Ref: 6129

## LEESTON PLAN CHANGE - RFI RESPONSE

Thank you for your letter dated 19 September requesting further information regarding Plan Change PC190062: Private Plan Change Leeston. Baseline Group has prepared the following response.

- ODP Boundary
- Parcel Boundaries
- Living 1 Zone
- Living 2 Zone
- Indicative Primary Road
- Indicative Secondary Road
- Future Roading Connection

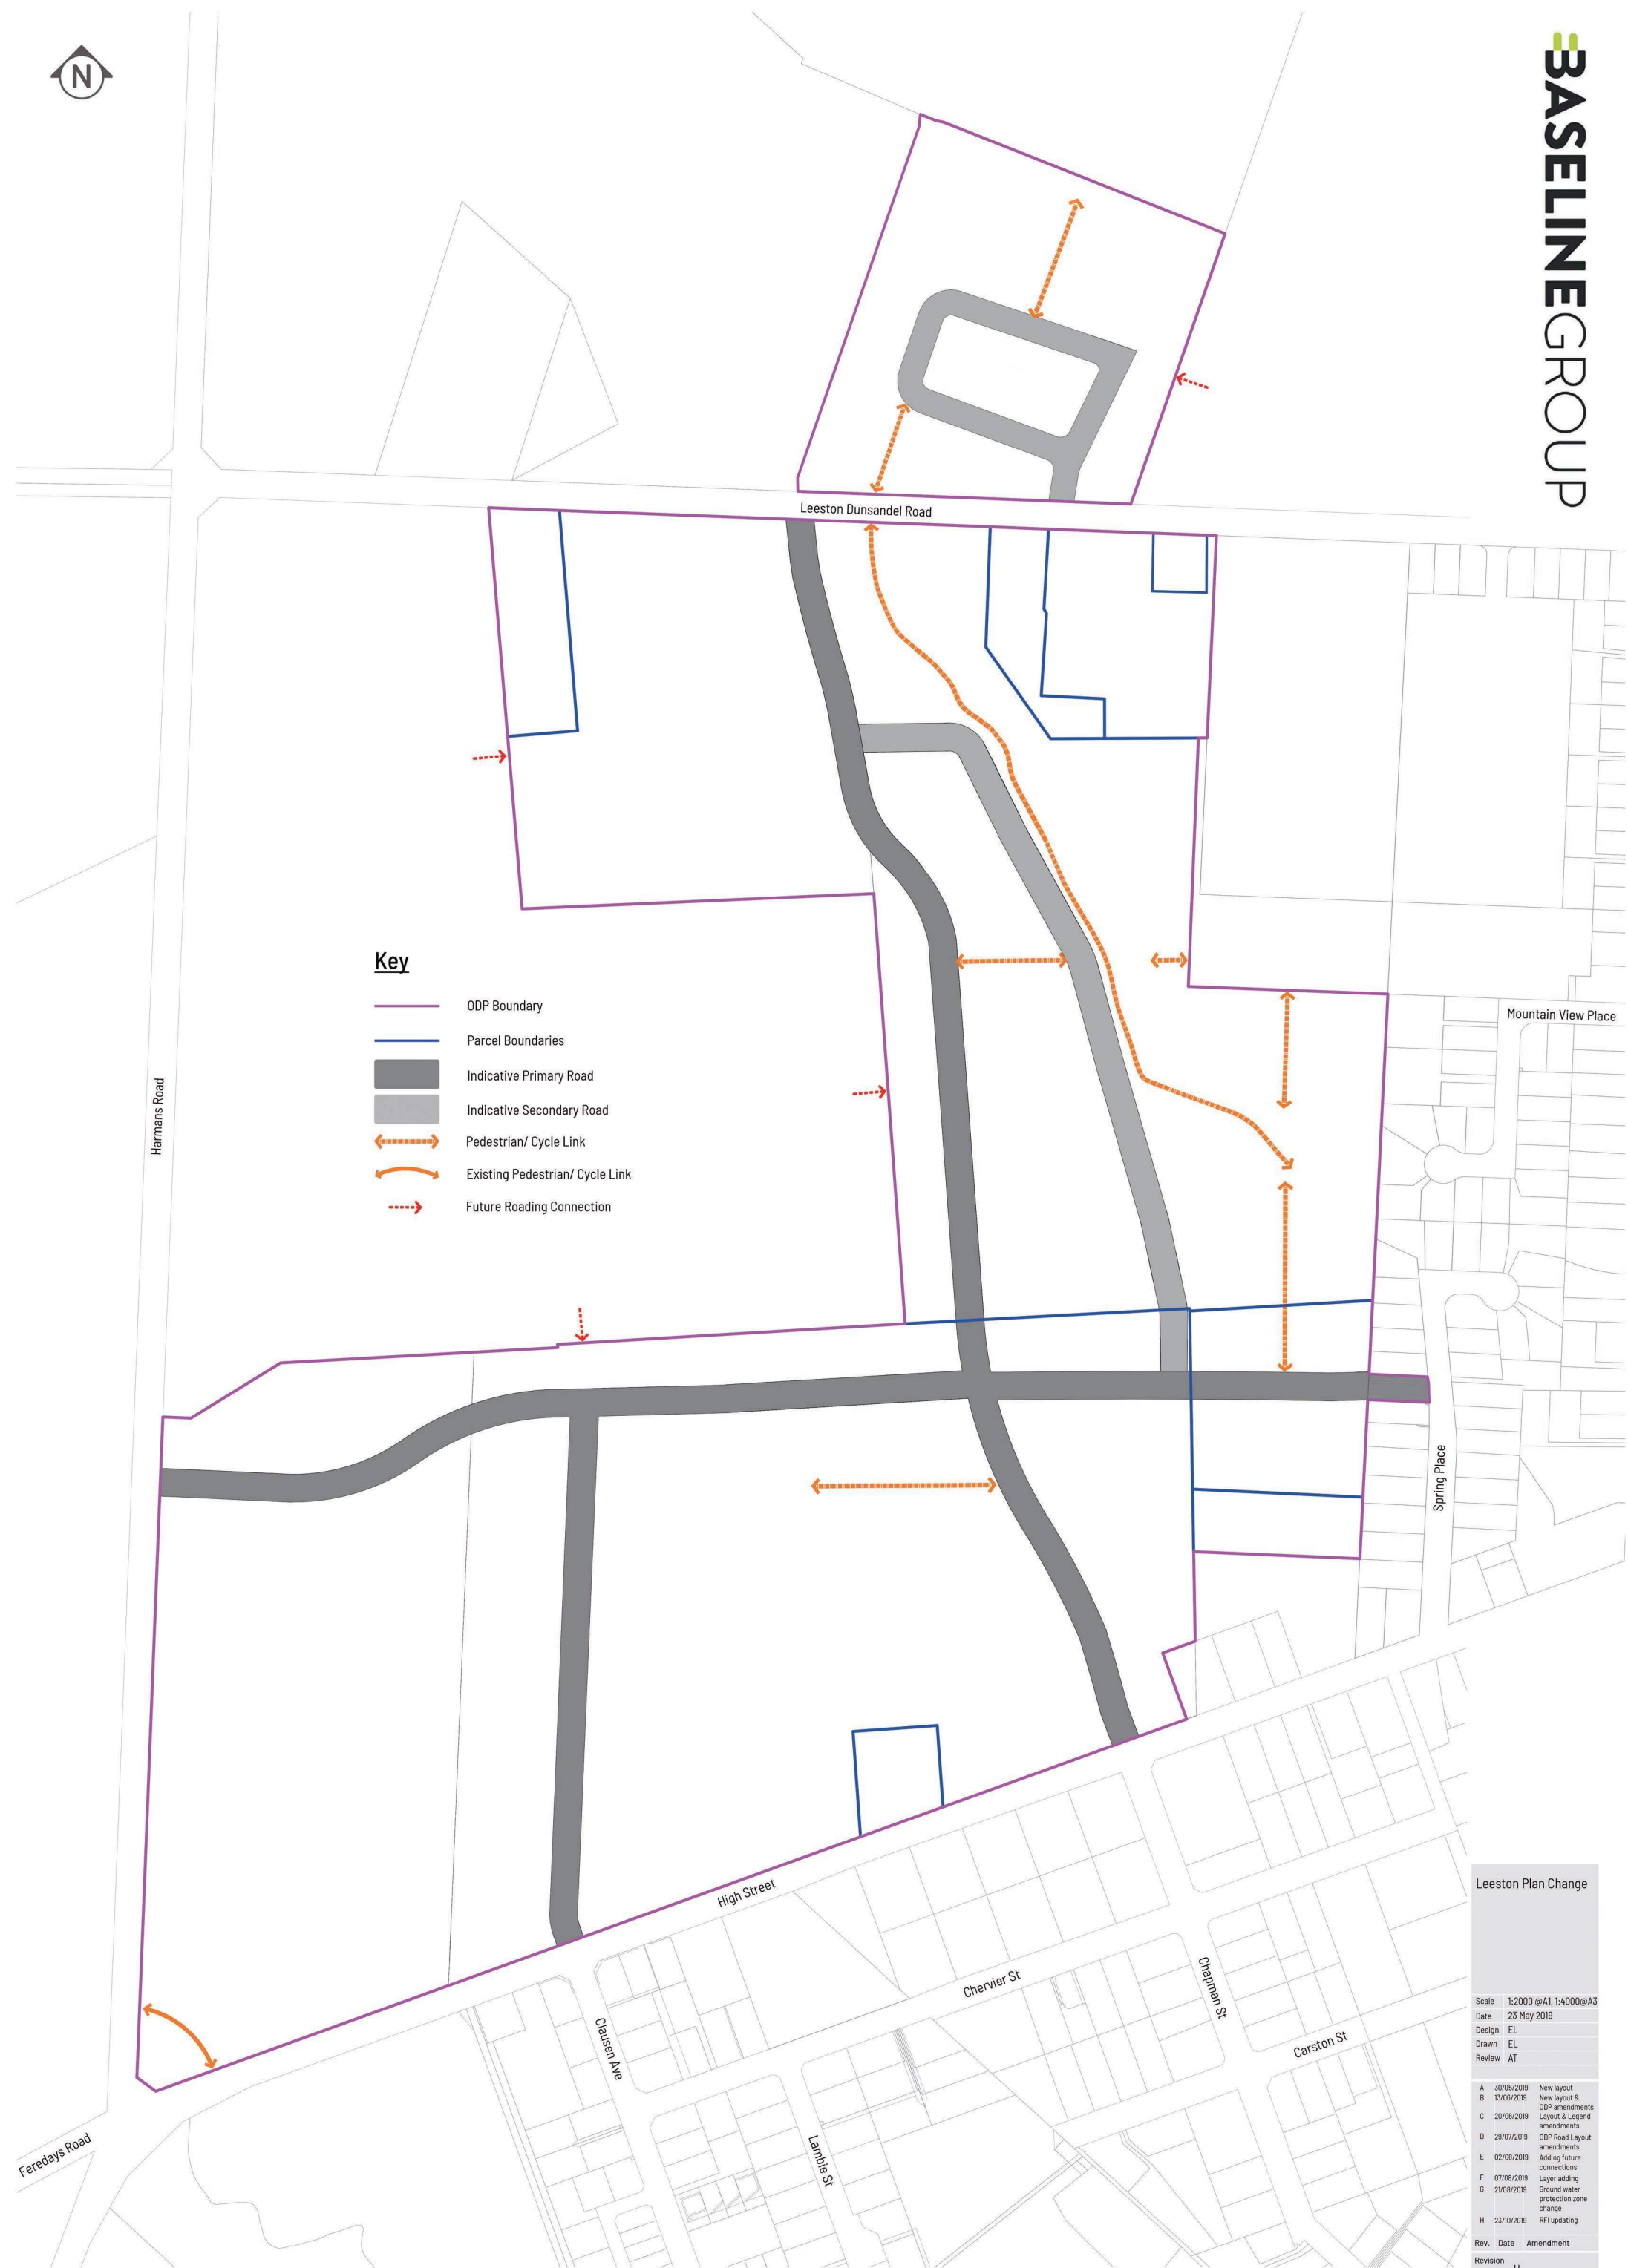
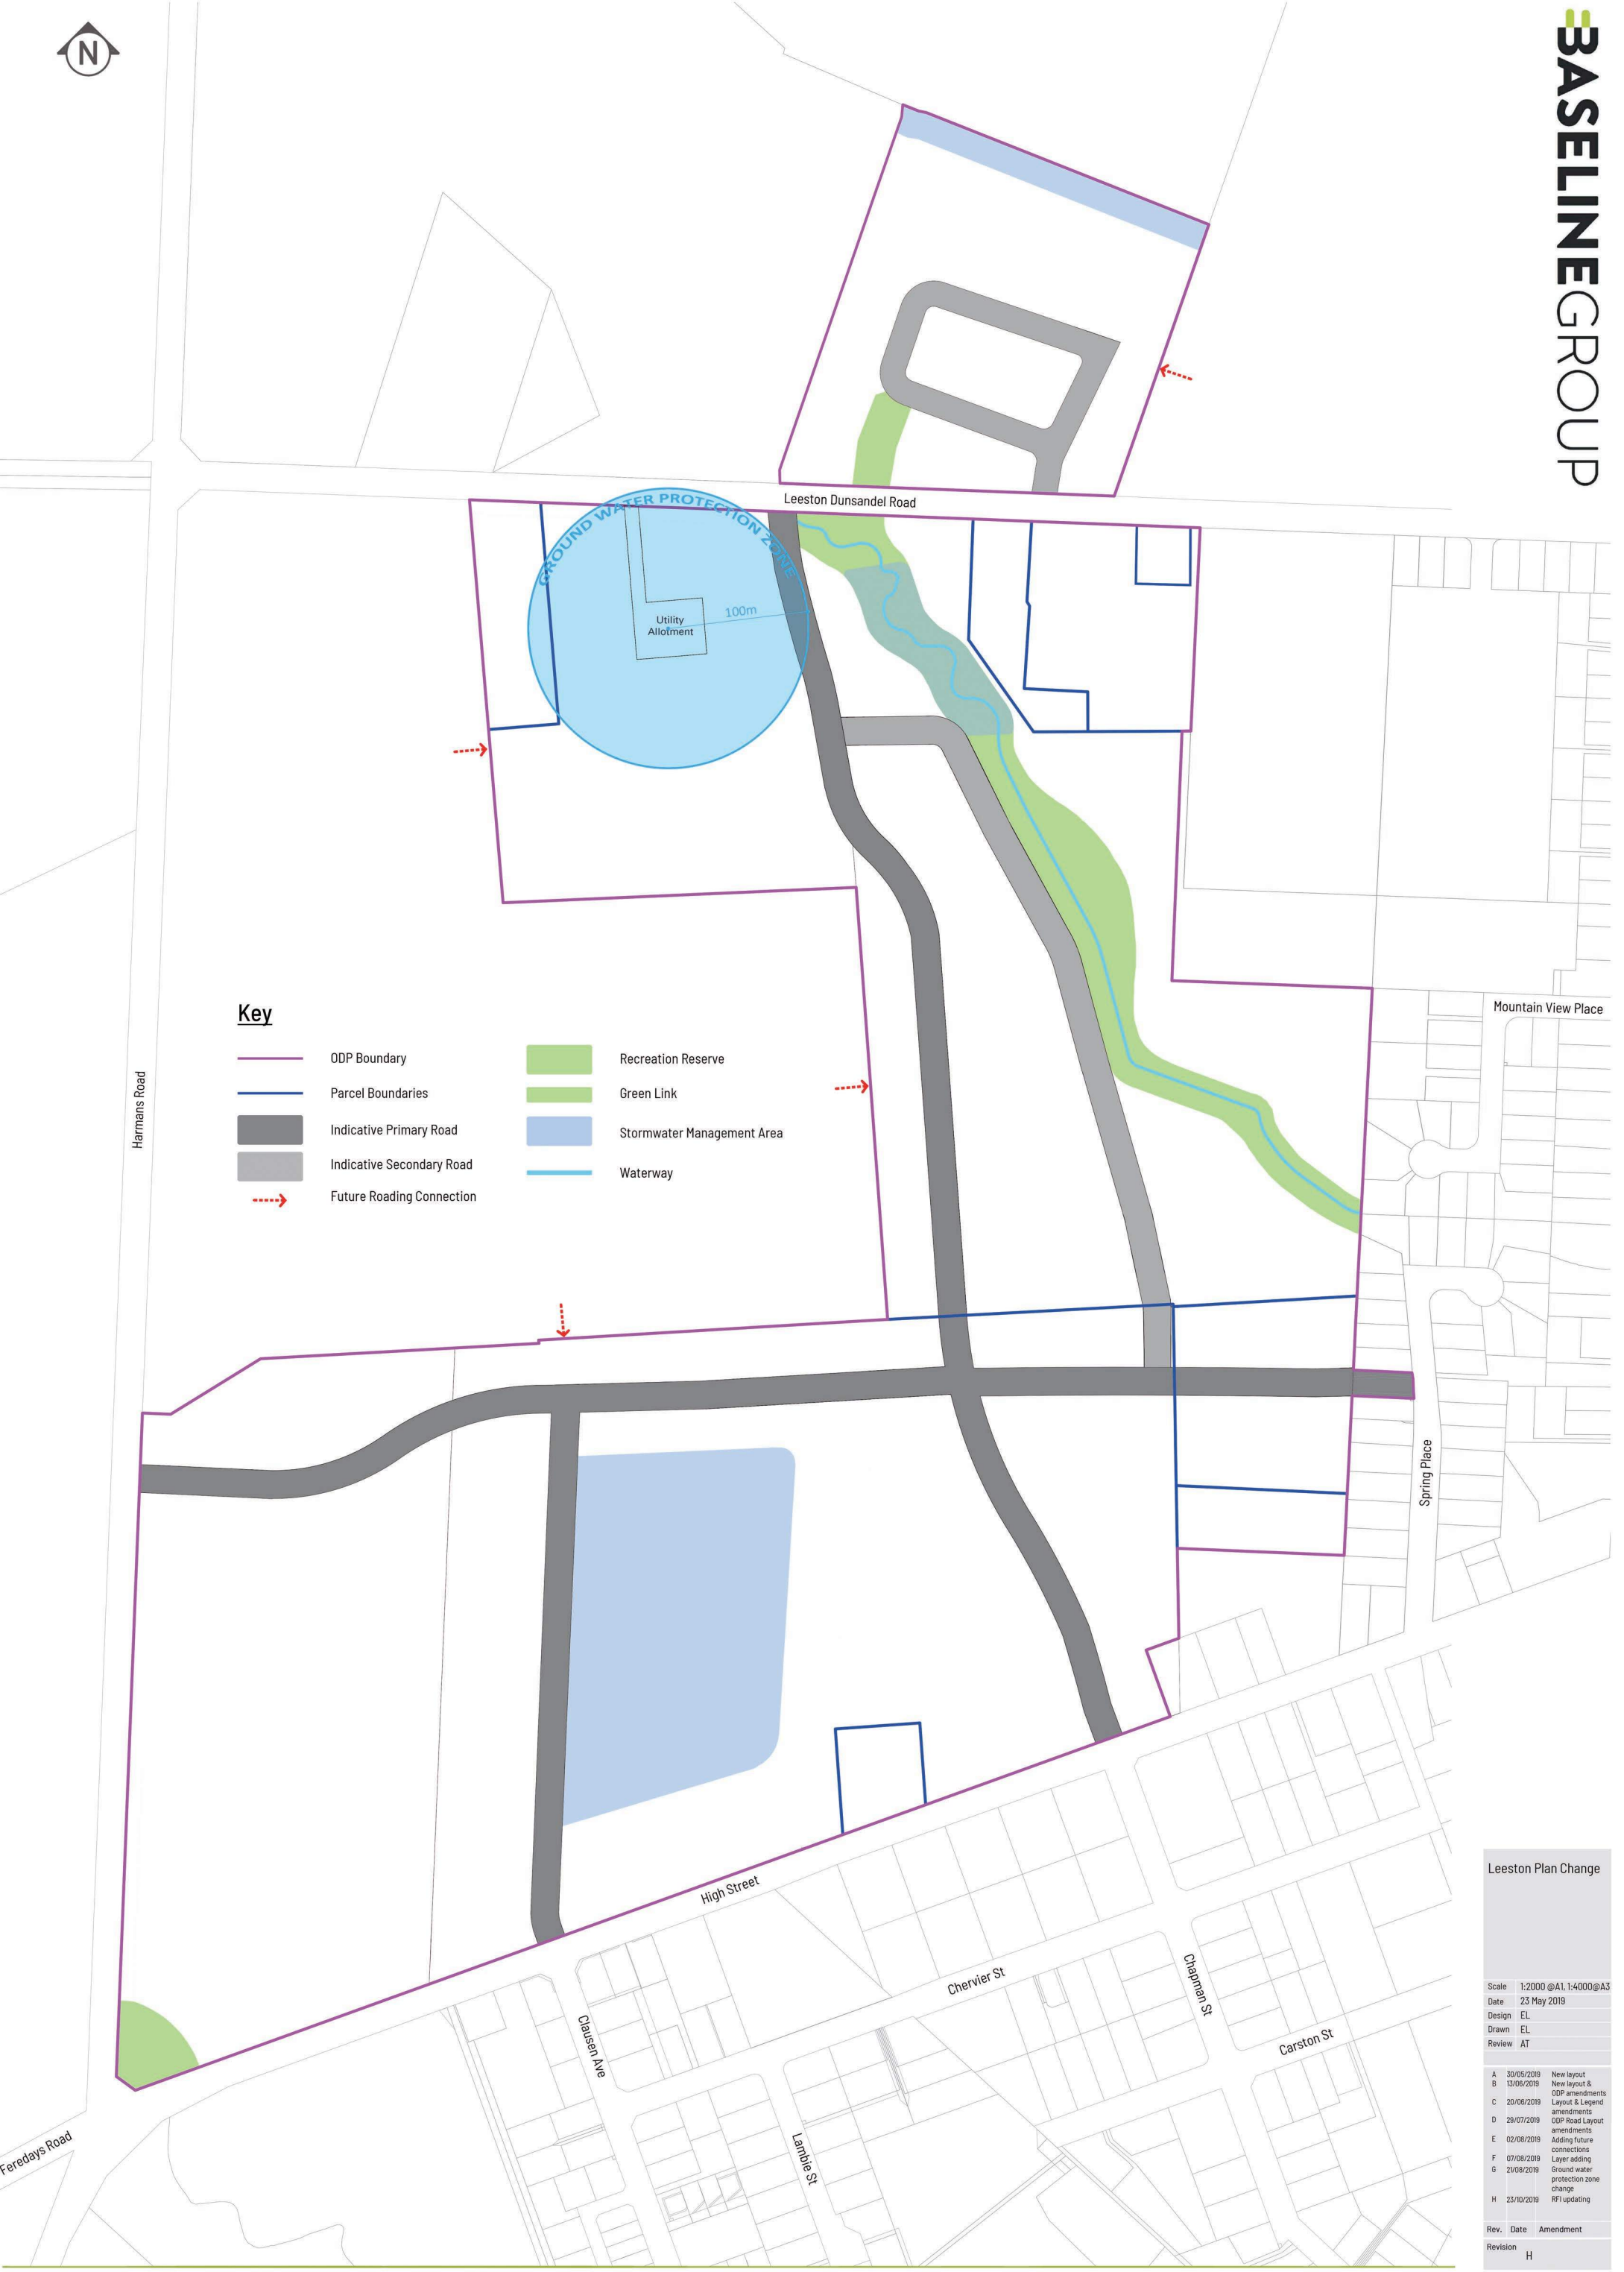
12. As highlighted in yellow below, the ODP should show a specific pedestrian/cycle link along the main reserve/water course alignment. The ODP should also show a pedestrian/cycle link from the northern part of the to the future stormwater reserve area along the northern boundary of the site.

16. *To address CPTED issues, the proposed reserve along the creek should have extensive road frontages, rather than being behind houses, as reflected in the indicative subdivision plan included in the Transportation Assessment.*

*17. There are small inconsistencies between the overall ODP and the transport network in terms of the pedestrian/cycle links. Please resolve these. It is noted that a continuous alignment is preferred.*

*18. A future roading connection is also desirable from the northern Living 2 residential portion of the site to the west and south, connecting into the balance Rural (Outer Plains) Zone, to future proof accessibility within this locality.*

*19. The names of the surrounding roads should also be shown on the ODP.*

These have been added to the ODP and a revised copy of the ODP is attached in Appendix 4.

The ODP (see appendix 4) has been amended so the reserve along the creek has road frontage with the secondary road.

The ODP has been amended to resolve the inconsistencies between the overall ODP and the transport network plan and is attached in Appendix 4.

A future road connection has been provided on the ODP from the northern Living 2 portion to the west. Three roading connections to the block of land west of the plan change site is considered sufficient to future proof any development. It is noted the site to the west is zoned Outer Plains, so any future residential development would require a plan change and an outline development plan.

Road names have been added to the ODP plans in Appendix 4.

The ODP plans have been amended and are attached to this letter in Appendix 4.
